Date: Wed, 18 Sep 2024 8:32:34 AM (UTC)
Sent: Wed, 18 Sep 2024 8:32:30 AM (UTC)
Subject: FW: 24/0274 Coc-Y-North Bungalow, Barn At Coc-Y-North Lane Rhiwderin Newport NP10 8RR
From: Cooke, Jacob (Senior Planning Officer) <Jacob.Cooke@newport.gov.uk >
To: Cooke, Jacob (Senior Planning Officer) <Jacob.Cooke@newport.gov.uk >;

From: Harris, Matthew (Ecology Officer) <Matthew.Harris@newport.gov.uk >
Sent: Tuesday, September 17, 2024 5:11 PM
To: Cooke, Jacob (Senior Planning Officer) <Jacob.Cooke@newport.gov.uk >
Subject: RE: 24/0274 Coc-Y-North Bungalow, Barn At Coc-Y-North Lane Rhiwderin Newport NP10 8RR

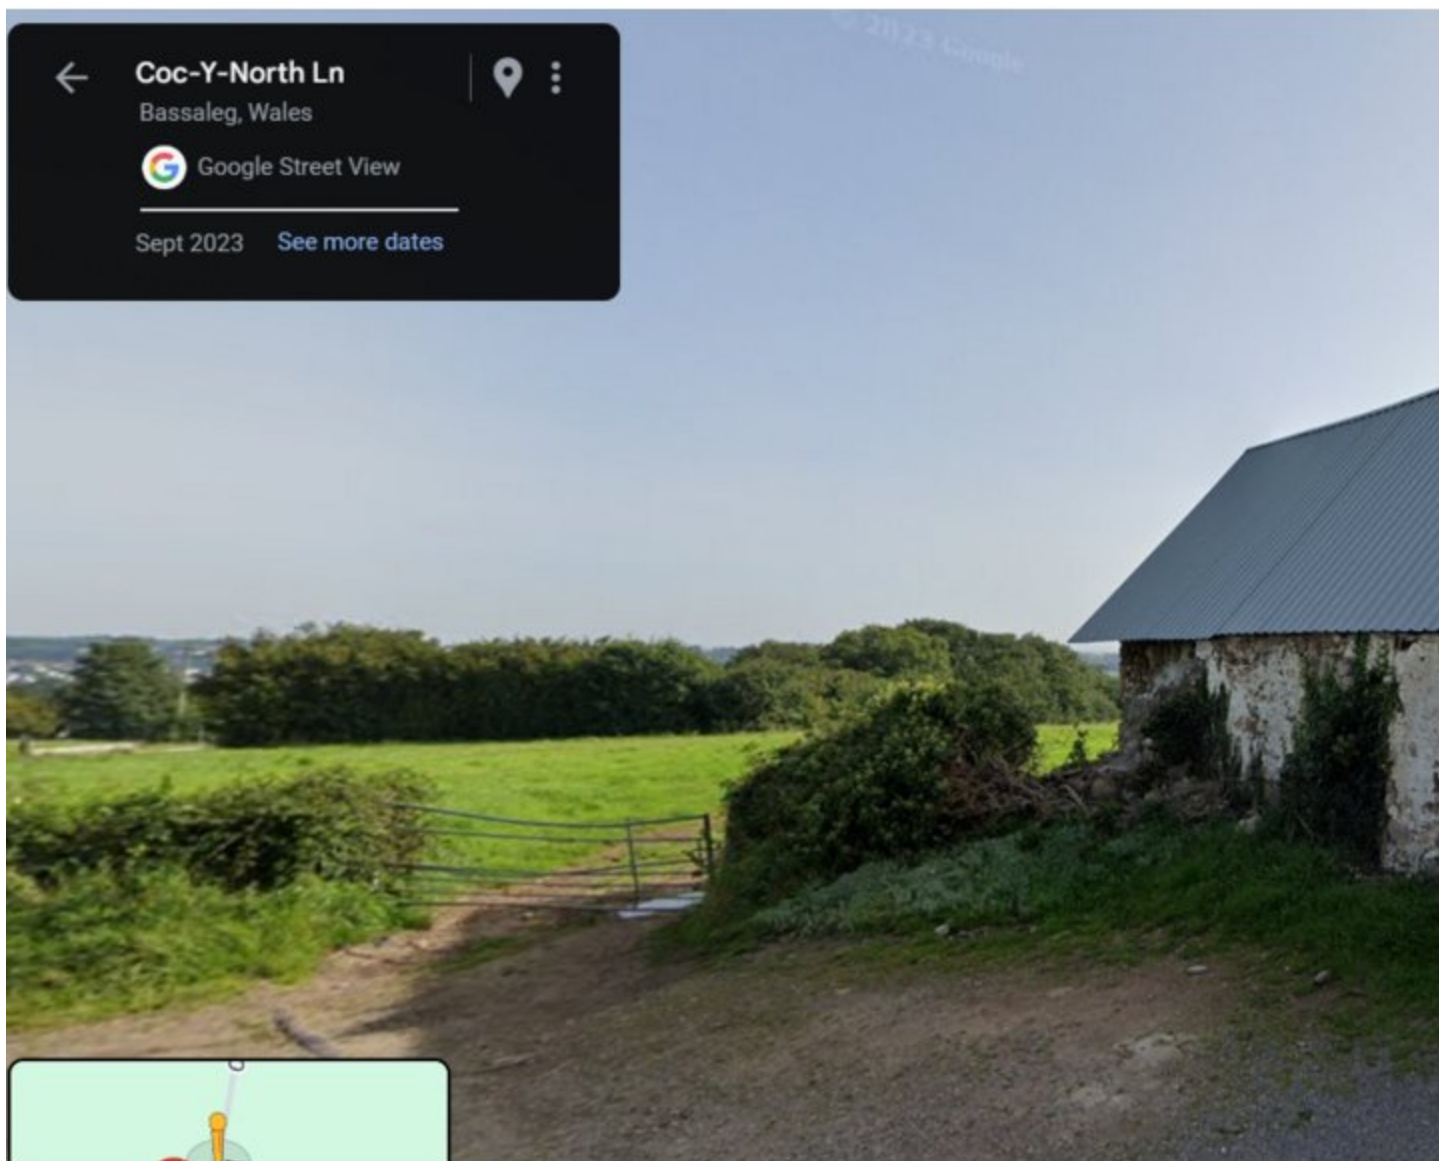
Jacob, if this is the building concerned, then I would not ask that the bat survey be repeated-

A single-skin metal roof such as this would not normally be suitable for bats, because it gets too hot in the sun and too cold in the dark. Normally for bats we are looking for a tiled roof with some sort of internal lining which is able to buffer against extremes of high and low temperature. Either that or wooden fascias, barge boards or soffits which again protect against temperature fluctuations.

On this occasion I would not ask for the survey to be repeated.
